SOUTHWEST ROYALTIES, INC.

8. Well Name and No. McINTYRE G FEDERAL #001

NOTICE OF INTENT TO PLUG AND ABANDON

Permanent Abandonment of Federal Wells
Conditions of Approval (LPC Habitat)

CURRENT GRAYBURG JACKSON; SR-Q-G-SA WELL

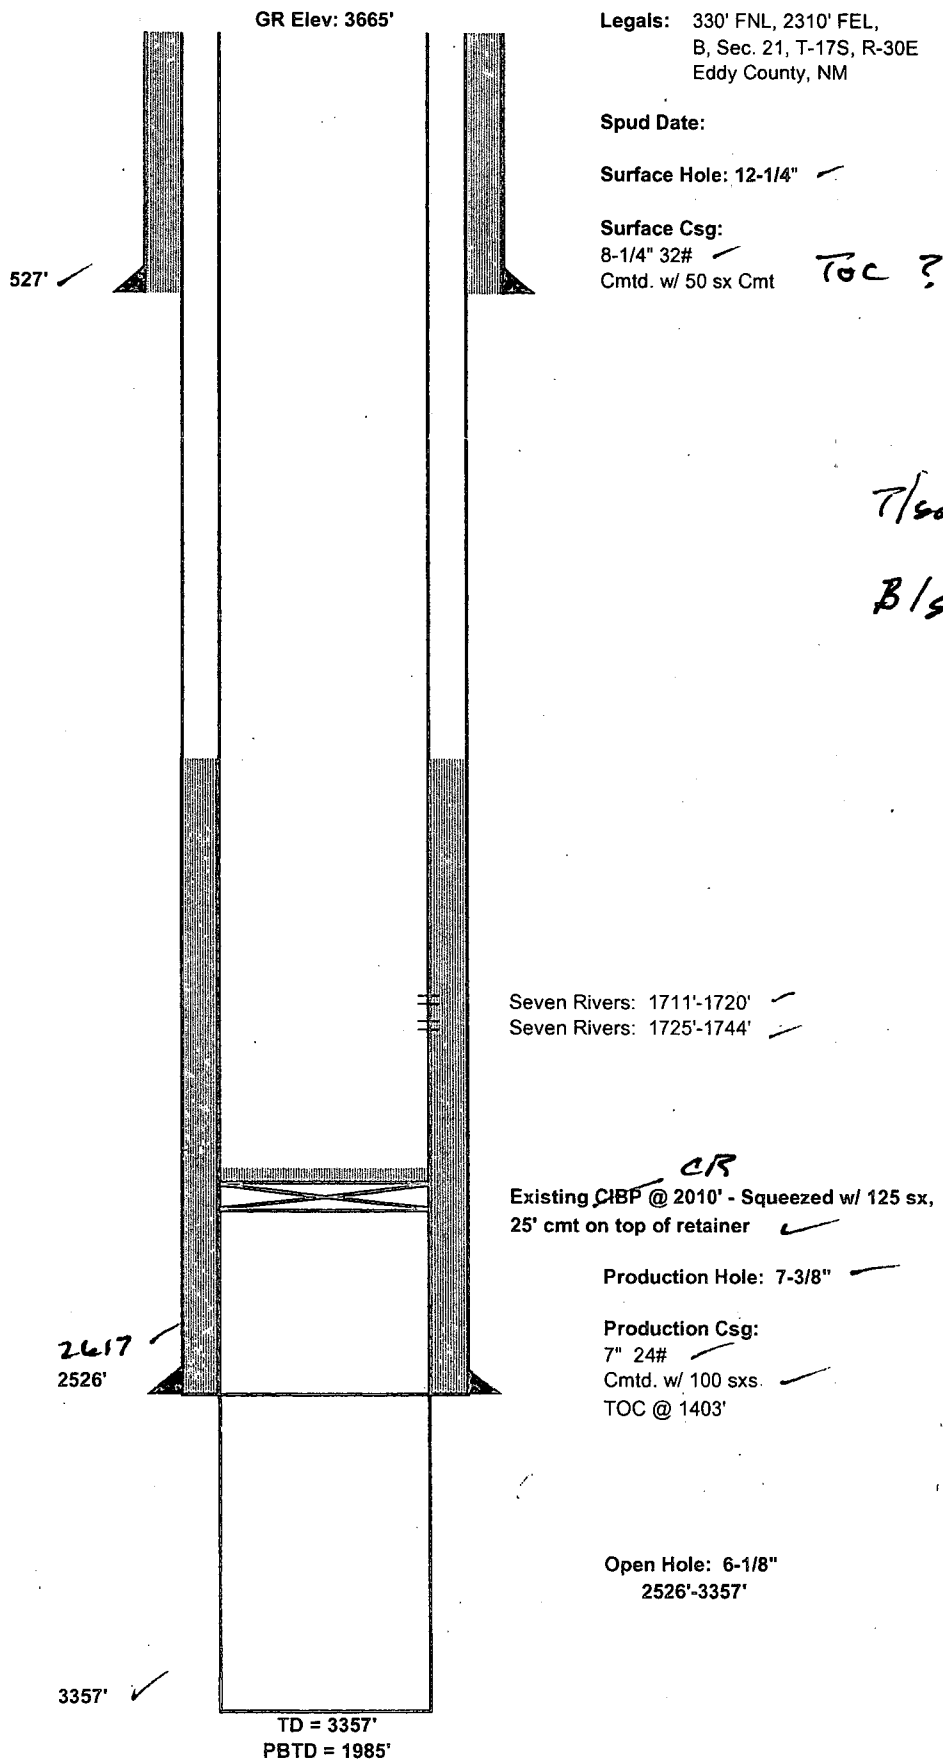
3/25/20
Accepted for record - NMOCDSet CIBP @ 1661, Cap w/ 25 SX
At Cut-off verify cmt surf all
annulus. Remedial may be needed.
Surf csq.

Below ground level dry hole marker required
